## Product Change Notification: MFOL-15GCKY608

CCB 7196.024 Final Notice: Qualification of MTAI as a new final test site for ATMEGA644-20PU, ATMEGA644P-20PU, ATMEGA32-16PU, ATMEGA8515-16PU, ATMEGA162-16PU, ATMEGA8535-16PU, AT89S8253-24PU, AT89C51RC-24PU, ATMEGA8535L-8PU and AT89C55WD-24PU catalog part numbers (CPN) available in 40L PDIP (.600in) package.

# CCB 7196.024

### PCN #: MFOL-15GCKY608

# Pre and Post Change Summary - Tube

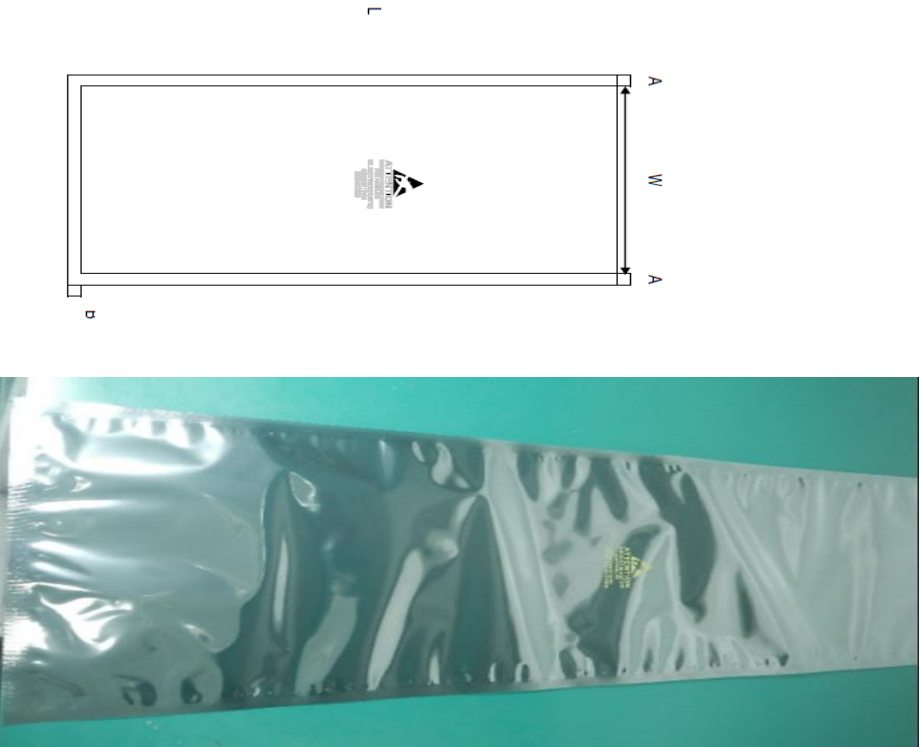
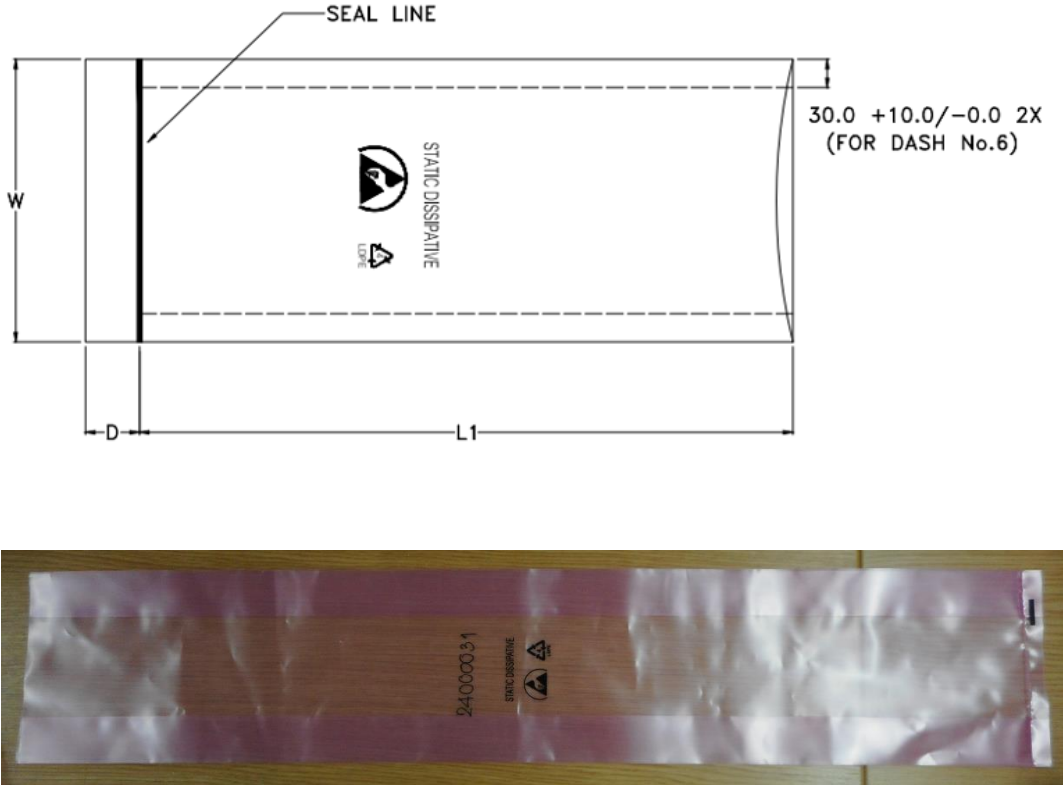
Location	Tube Length (inch)	Unit per Tube	Tube per Bag	Tube Color
MPHL	23.75 +/- 0.05	10	24	Transparent Clear
MTAI	23.75 +/- 0.05	10	24	Transparent Clear
